VOLUME 10

CNP UNITS 1 AND 2 IMPROVED TECHNICAL SPECIFICATIONS CONVERSION

ITS SECTION 3.5 EMERGENCY CORE COOLING SYSTEMS (ECCS)

Revision 0

LCO 3.5.5

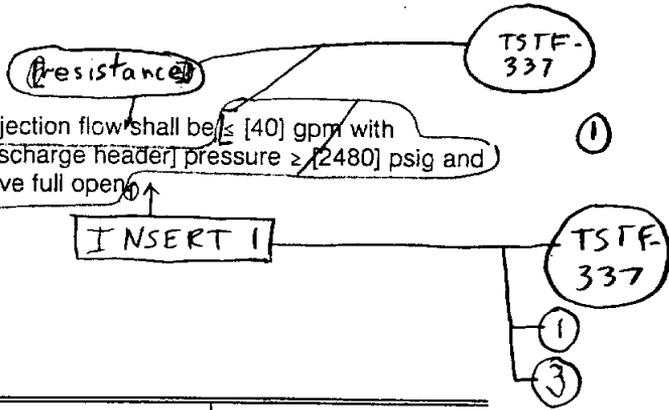
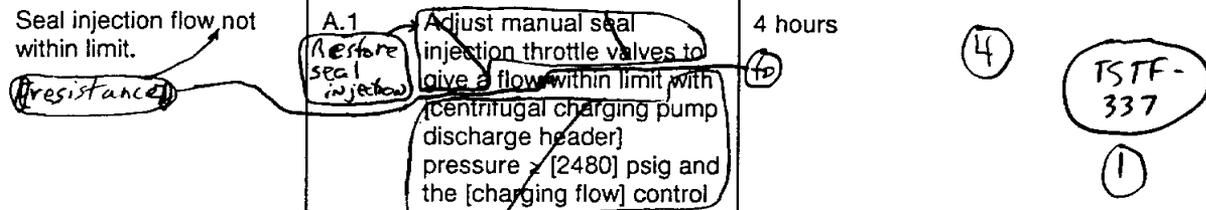
Reactor coolant pump seal injection flow shall be \leq [40] gpm with [centrifugal charging pump discharge header] pressure \geq [2480] psig and the [charging flow] control valve full open.

① \geq 0.2117 ft/gm² or within the limit of Figure 3.5.5-1 ①
0.227 P 3

$Q \geq (0.2117)$ ft/gpm² or within the limit of Figure 3.5.5-1. (1)

The LCO is not strictly a flow limit, but rather a flow limit based on a flow line resistance. In order to establish the proper flow line resistance, a pressure and flow must be known. The flow line resistance is established by adjusting the RCP seal injection flow in the acceptable region of Figure 3.5.5-1 at a given pressure differential between the charging header and the RCS. The centrifugal charging pump discharge header pressure remains essentially constant through all the applicable MODES of this LCO. A reduction in RCS pressure would result in more flow being diverted to the RCP seal injection line than at normal operating pressure. The valve settings established at the prescribed centrifugal charging pump discharge header pressure result in a conservative valve position should RCS pressure decrease. The flow limits established by Figure 3.5.5-1 ensures that the minimum ECCS flow assumed in the safety analyses is maintained. 3
